GRAND PRODUCTS, INC.

MODIFICATION PROCEEDURE FOR AS-2518-35

MICROPROCESSOR MOD'S

Board Revision - 35

FIGURE I

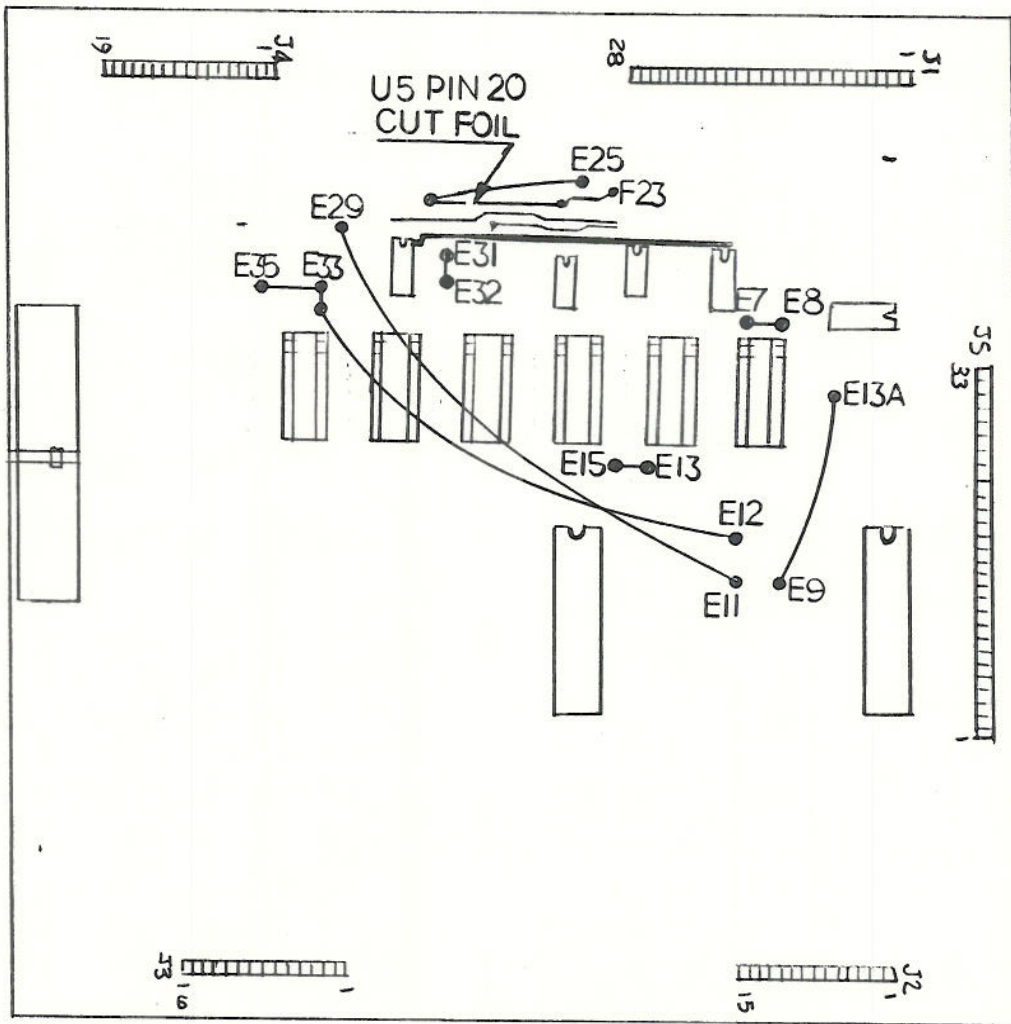
Cut trace (rear) U-11	Fig. 2
Cut trace to U14 pin 3	Fig. 2
Cut trace to U5 pin 20	Fig. 1
Connect U9 23 to U18 11	Fig. 2
Connect U9 22 to U14 3	Fig. 2
Connect E33 to E35	Fig. 1
Connect E12 to E33	Fig. 1
Connect E7 to E8	Fig. 1
Connect E31 to E32	Fig. 1
Connect E13 to E15	Fig. 1
Connect E13A to E9	Fig. 1
Connect E11 to E29	Fig. 1
Connect E25 to U5 20 thru feed hole

REMOVE ALL STRAPPING JUMPERS LABELED "E"
NOT SHOWN ABOVE
